**FIRE SAFETY FOLLOW UP INSPECTION**

<b>Factory Name</b>	Safaa Sweaters Ltd		
<b>Address</b>	Begumpur, Bokran, Monipur, Bhawl Gore		
<b>Inspection Date</b>	10/14/2015		
<b>Date Report Received</b>			
<b>Date of 1<sup>st</sup> Follow-up</b>	24/May/16	<b>Date of 2<sup>nd</sup> Follow-up</b>	19/July/16
<b>Date of 3rd Follow-up</b>	21/December/16	<b>Date of 4th Follow-up</b>	15th may 2017
<b>Date of 5th Follow-up</b>		<b>Date of 6th Follow-up</b>	
<b>Inspected by</b>	Dalower Hossain

2

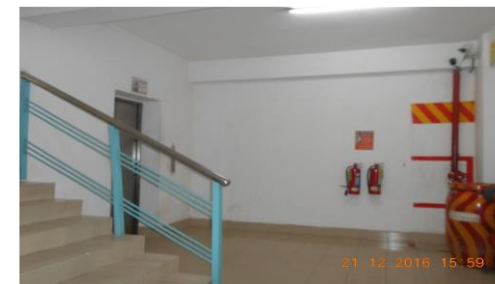
The elevator does not have the proper fire rating for the elevator door.

Provide the proper 2 hr fire rating for the shaft and 1.5 hr fire rating for the elevator door.

On 24/05/2016: Corrected. Factory has sealed openings near elevators.  
On 19/07/2016: Corrected. Factory has sealed the openings and penetrations near elevator.

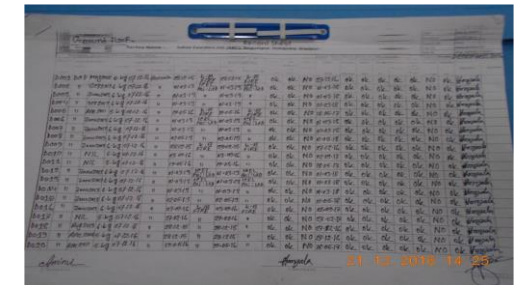
11 Inspection, testing and maintenance of portable fire extinguishers is not in accordance with NFPA 10.

Inspect, test and maintain the portable fire extinguishers and keep written records on-site, in accordance with NFPA 10 and ACCORD standards.

On 24/05/2016: Corrected. Note: Factory should update fire extinguisher maintenance checklist.  
 On 19/07/2016: Corrected. Factory is maintaining a standard checklist as per code.  
 On 21/12/2016: Corrected as per previous follow-up inspection.  
 On 15/05/2017 : Corrected.

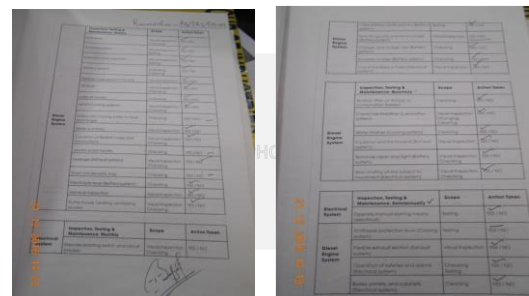
12 Inspection, testing and maintenance of the fire pump system is not in accordance with NFPA 20 and ACCORD standards.

Inspect, test and maintain the fire pump system and keep written records on-site, in accordance with NFPA 20 and ACCORD standards.

On 24/05/2016: Factory management confirms that they will inspect, test and maintain as per standard when the new fire pump system will be installed within 30th August, 2016.  
 On 19/07/2016: Corrected. Factory is maintaining a standard checklist as per code.  
 On 21/12/2016: Corrected as per previous follow-up inspection.  
 On 15/05/2017 : Corrected.
